Migrating from the LAN9115 to the LAN9210

1 Objective

The purpose of this application note is to assist SMSC customers with existing LAN9115 designs when upgrading to the new LAN9210 devices. Migrating from the LAN9115 to the LAN9210 will require PCB modifications to support the new LAN9210 package type and the HP Auto-MDIX PHY (even if this mode is not used). This application note addresses all the differences between the LAN9115 and the LAN9210 devices, making this transition as easy as possible.

Figure 2.1 PCB Land Pattern

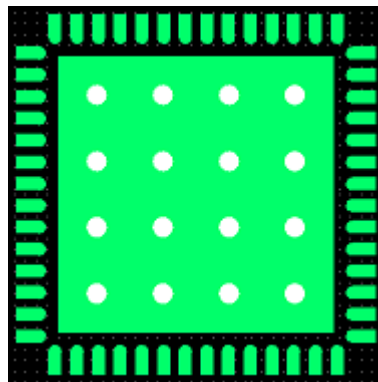
The LAN9210 is packaged in a 56-pin QFN with an exposed VSS pad. Therefore, the LAN9210 is not a drop in replacement for the LAN9115 and will require a new PCB. The recommended PCB land pattern can be found in Chapter 8 of the LAN9210 Datasheet. It is recommended to place a 4x4 grid of vias at 60mil spacing in the exposed pad area for connection to the board's ground plane, as shown in [Figure 2.1](#) below. Please consult with your Assembly House for their process capabilities and recommendations.

Figure 2.2 LAN9210 Transmit Circuit

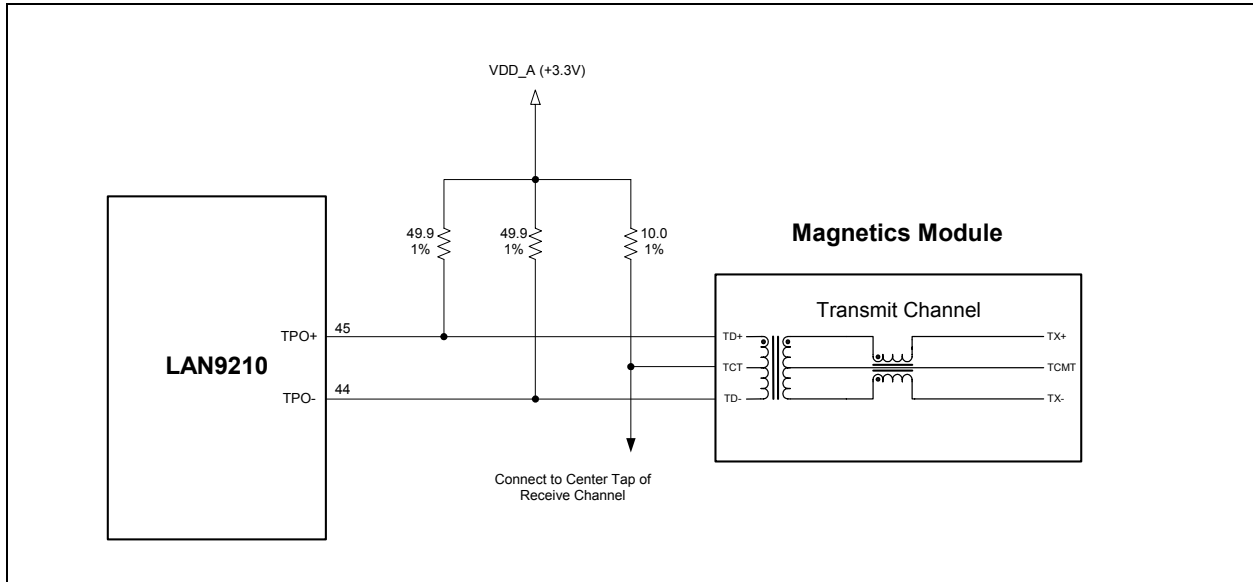
The differences between the LAN9210 and the LAN9115 are as follows:

- The LAN9210 uses magnetics that support HP Auto-MDIX.
- The device-side center tap of the transmit core (TCT) is attached to the device-side center-tap of the receive core (RCT).
- The 49.9 ohm resistors should be placed as close as possible to the LAN9210.

Figure 2.3 LAN9210 Receive Circuit

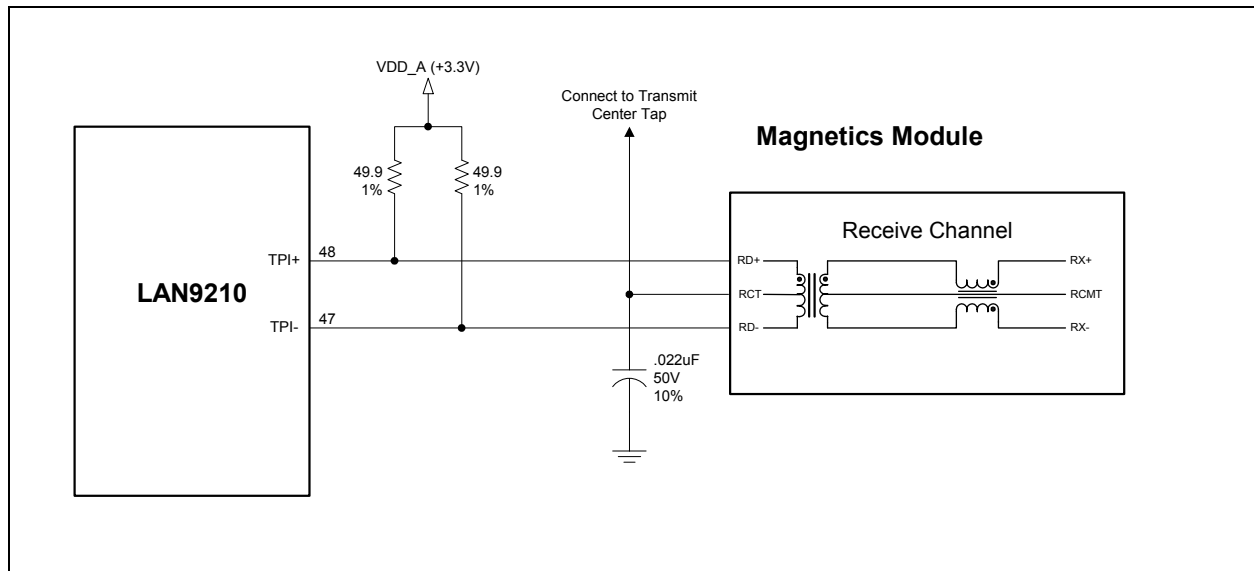
The differences between the LAN9210 and the LAN9115 are as follows:

- The LAN9210 uses magnetics that support HP Auto-MDIX.
- The LAN9115 had two 6.8nf capacitors, one in series with each side of the twisted pair. These are eliminated (shorted) in the LAN9210.
- In the LAN9115, the mid-point between the two 49.9 ohm resistors is tied to the center tap of the magnetics (RCT) and to a 0.01uF bypass capacitor to ground. In the LAN9210, both resistors are tied to VDD_A (+3.3V), and the 0.01uF bypass capacitor has been eliminated. The center-tap of the receive channel of the magnetics is tied to the transmit center tap (TCT) and to a common 0.022uF bypass capacitor to ground.
- The 49.9 ohm resistors should be placed as close as possible to the LAN9210.

Figure 2.4 Power Connections

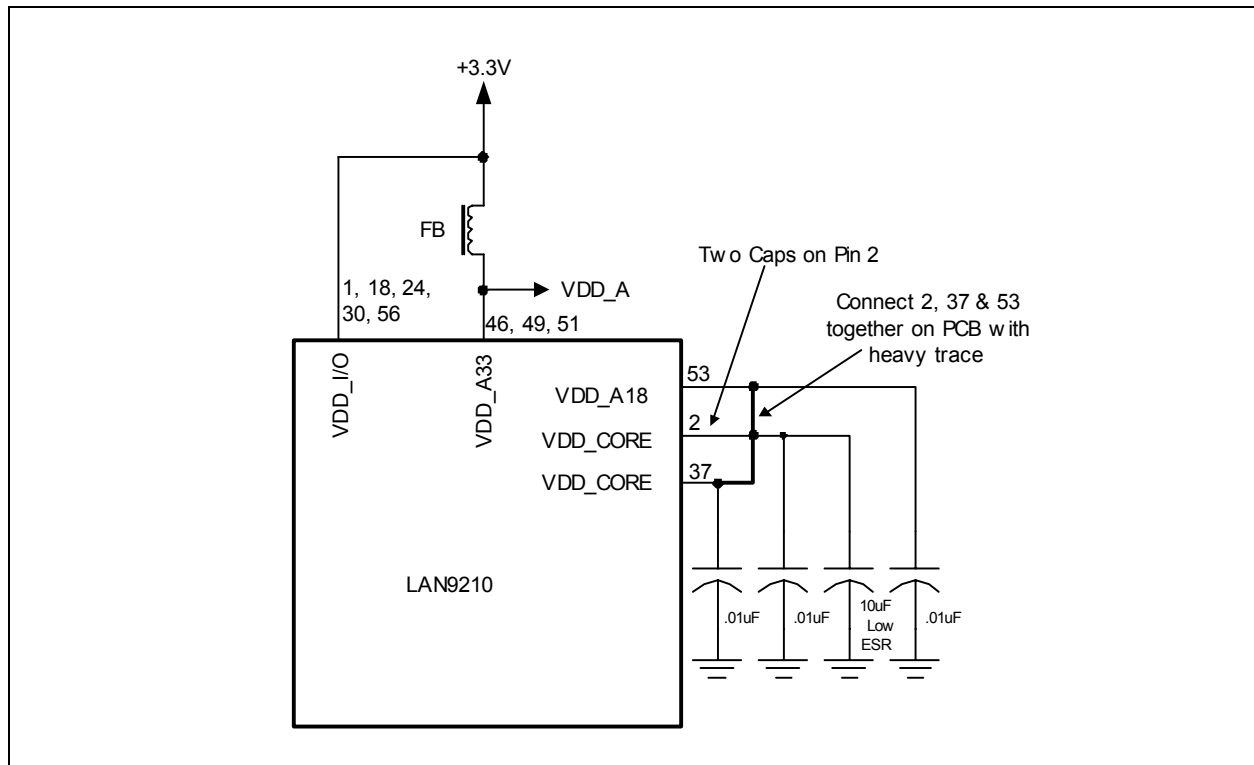
The LAN9115 has several different ground pins (GND_IO, VSS_A, GND_CORE, VSS_PLL and VSS_REF). However, the LAN9210 uses a single ground connection (VSS) on the exposed pad. Also, the LAN9210 does not have VDD_PLL, VDD_REF, and VREG power pins.

The LAN9210 has a VDD_A18 (pin 53) that must be externally connected to VDD_CORE (pins 2, 37) with traces at least 10 mil wide and connected to a 10uF low ESR ceramic capacitor. Each of these 3 pins must be individually decoupled with a 0.01uF capacitor as close as possible to the pin, as shown in Figure 2.4, "Power Connections".
